Wollongong Local Planning Panel Assessment Report | 17 October 2018

WLPP No.	Item 2
DA No.	DA-2018/803
Proposal	Residential -demolition of existing structures and construction of a seven (7) storey residential flat building consisting of 38 units over basement parking
Property	12-16 Beatson Street, WOLLONGONG
Applicant	ADM Architects
Responsible Team	Development Assessment and Certification - City Centre Team (NL)

ASSESSMENT REPORT AND RECOMMENDATION

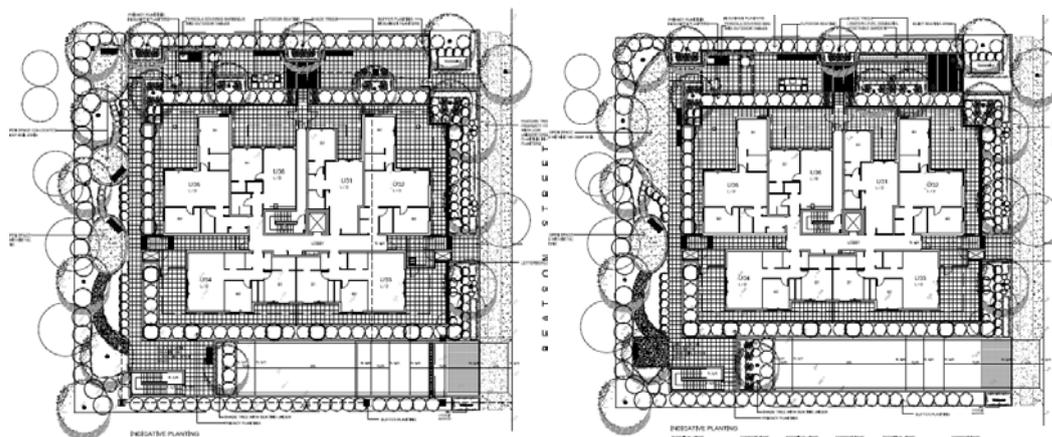
- *Built Form and Scale: The Panel believes that the streetscape interface would be improved if made more solid. Instead of presenting glazed balustrades to the street at ground level for example, it may be better to introduce solid spandrels with setback louvred screens to the flooding chamber. In addition, the extent of roof and square columns of the penthouse north facing roof appears heavy handed. This roof element may be better setback and cantilevered, with an expressed steel fascia.*

Response: The columns have been removed and roof cantilevered as recommended as shown below.

DRAWING TITLE
 Landscape Concept Plan

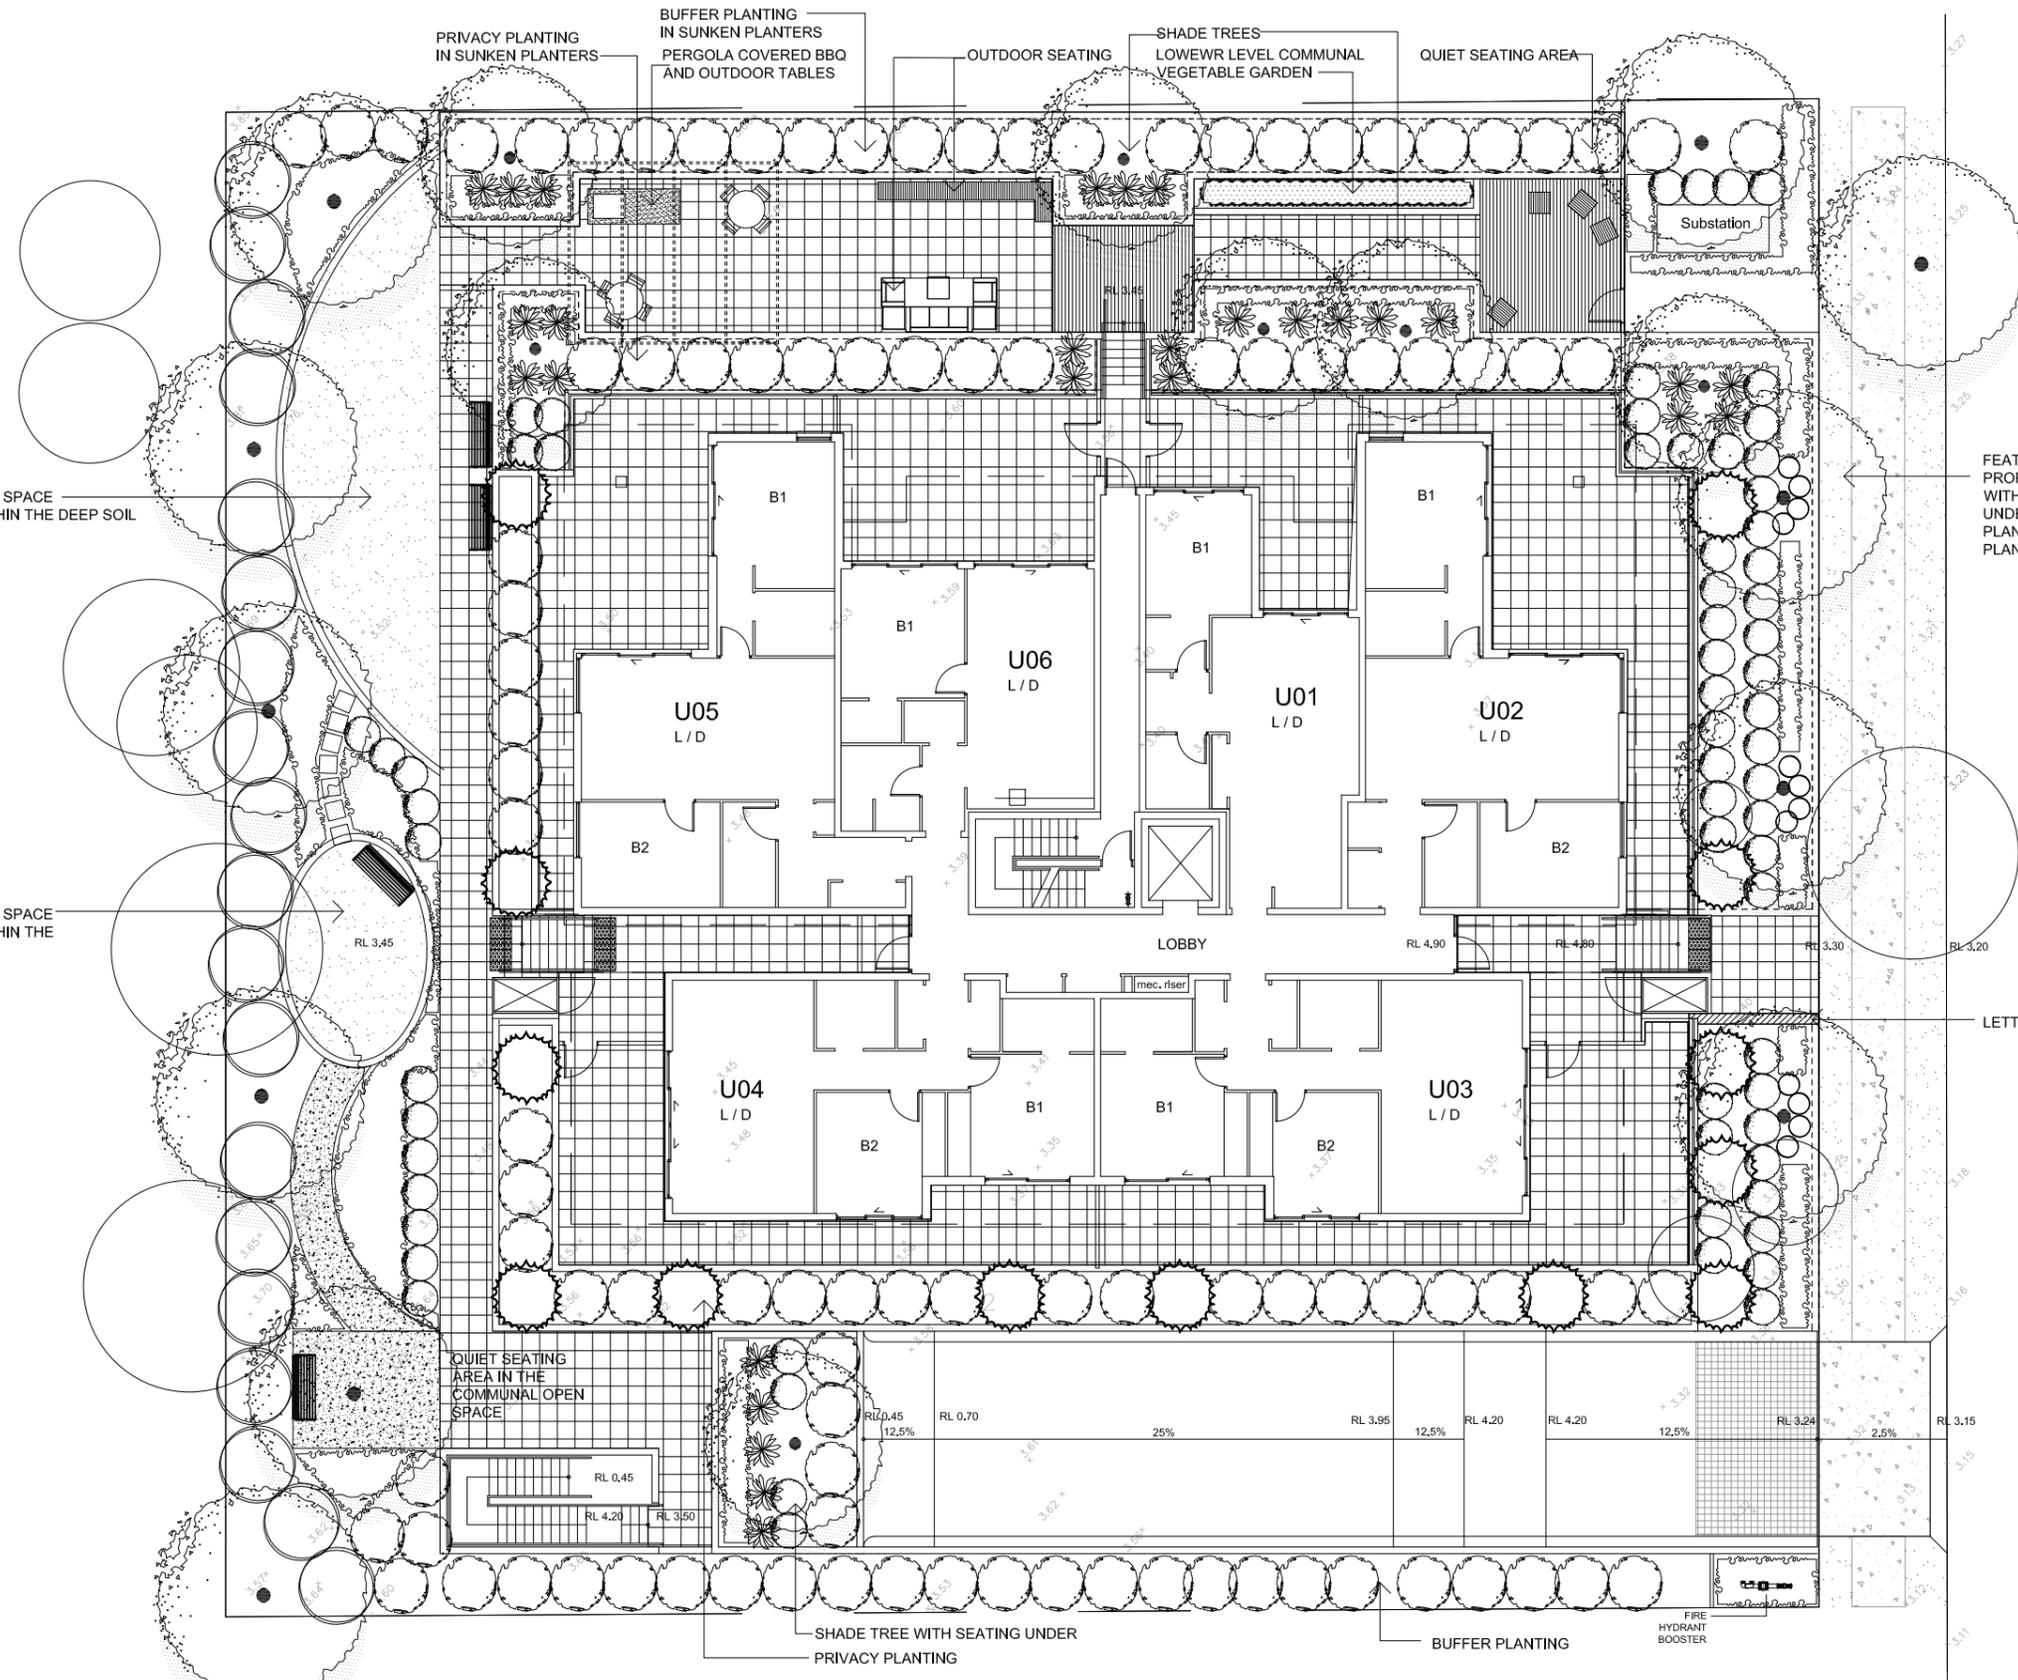
- *The deep soil landscape along the western boundary is contiguous and well connected to parcels of DSZ in neighbouring developments. The function proposed within the DSZ is acceptable and will allow a contrast to the hardscape courtyards to the north. However, the similarity in size between the three lawns reduces their variety / potential for use. The proponent should reduce the number of lawns and create two distinct sized lawns to allow both passive and semi-active play (young kids / families). The adjoining small paved court at the southern end of the DSZ (adjacent to the fire stair) should be integrated with the DSZ rather than creating a dead end. The planting above the carpark entry could be widened towards the west as a result. All seats should be removed from lawns and placed on the adjacent paved path or deleted.*

Landscape	<p>The COS consists of a series of similarly sized and treated courtyards and lawns with gardens between. The panel feels that to address the ADG's requirements that spaces and facilities cater to a variety of ages and uses, more consideration should be given to these spaces.</p> <p>The two paved courtyards to the northern part of the site are suitably located to take advantage of solar access and show outdoor eating and sitting areas. Unfortunately the similarity in scale of these two spaces limits their potential use. Therefore, it is recommended to break the eastern courtyard into smaller spaces, perhaps changing the feel of these by altering the ground treatment and/or density of the surrounding planting. Consider the arrangement of space – threshold – space to enclose some of these smaller spaces as more intimate gardens rooms. The spatial and furniture arrangement in the western courtyard needs more consideration with regards to circulation and function.</p> <p>The deep soil landscape along the western boundary is contiguous and well connected to parcels of DSZ in neighbouring developments. The function proposed within the DSZ is acceptable and will allow a contrast to the hardscape courtyards to the north. However, the similarity in size between the three lawns reduces their variety / potential for use. The proponent should reduce the number of lawns and create two distinct sized lawns to allow both passive and semi-active play (young kids / families). The adjoining small paved court at the southern end of the DSZ (adjacent to the fire stair) should be integrated with the DSZ rather than creating a dead end. The planting above the carpark entry could be widened towards the west as a result.</p> <p>All seats should be removed from lawns and placed on the adjacent paved path or deleted.</p>

Response: The landscape concept plan has been amended as recommended as shown below.
